**UNITED STATES ENVIRONMENTAL PROTECTION AGENCY  
REGION 8**

**JM Shafer Generating Station Fact Sheet**

**Pretreatment ICIS Number:** CO-PF00107

**Facility Name and Address:** Tri-State Generation and Transmission Association, Inc.  
– JM Shafer Generating Station  
6811 Weld County Road #31  
P.O. Box 208  
Fort Lupton, CO 80621

**Figure 6 - Outfall 001- Cooling Tower Monitoring Point**

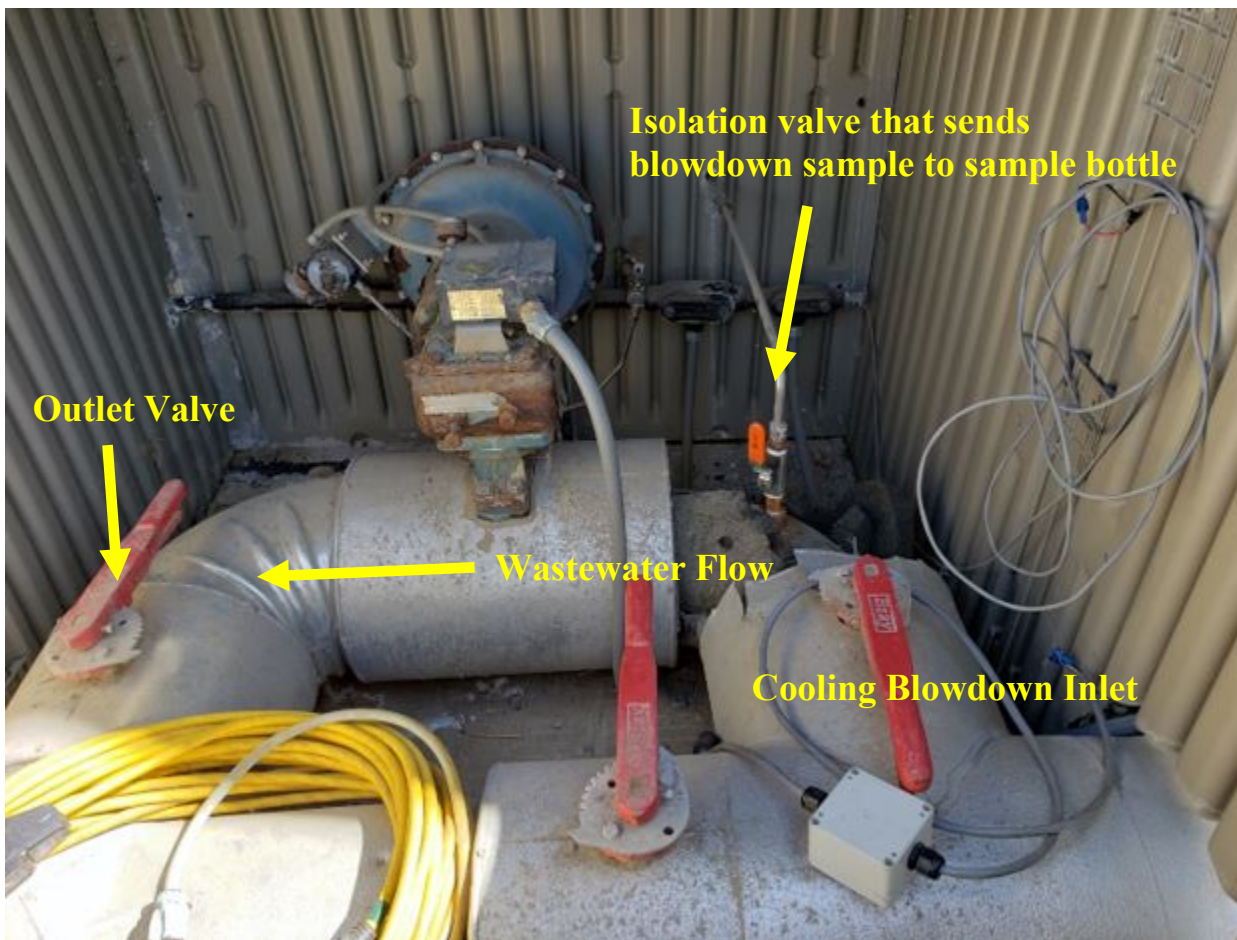
### **3. Tri-State disagrees with the EPA’s requirement to use a 24-hr flow proportional composite sampling method for collection of the required quarterly monitoring samples at Outfall 001.**

Tri-State disagrees with the EPA’s requirement to use a 24-hr flow proportional composite sampling method for collection of the required quarterly monitoring samples at Outfall 001 (representing only cooling tower blowdown water).

Part 2(A) of the Discharge Requirements Notice states that “Samples and measurements taken at Outfalls 001 and 002 shall be representative of the volume and nature of the discharge of the production day.” Water in the cooling tower is continuously recirculated and mixed, and the entire volume of the cooling tower water system (approximately 500,000 gallons) is turned over every ten to thirty minutes (varies by season-- see attached cooling tower water recirculation table). Water chemistry is maintained at a uniform and consistent quality to ensure the efficient operation of the cooling tower in accordance with manufacturer specifications and standard utility best practices. Therefore, a sample of cooling tower blowdown collected at any time is representative of the water in the entire cooling tower water system.

Based on supporting documentation that the water in the cooling tower water system is uniform in chemical characteristics and is representative of water that would be discharged during normal operations in a 24-hour time period, Tri-State requests that the required method of sampling for compliance monitoring in the new Discharge Requirements Notification be changed from 24-Hr composite sampling to a single quarterly individual grab sample to be collected during cooling tower blowdown while in normal operations.

EPA does not agree that a grab sample of the cooling tower blowdown at any time is representative of the water in the entire cooling tower water system. There is no cooling tower data that directly shows the levels of metals in blowdown water throughout the production day. The 24-hour flow proportional composite sampling requirement will remain in the notification of discharge requirements.
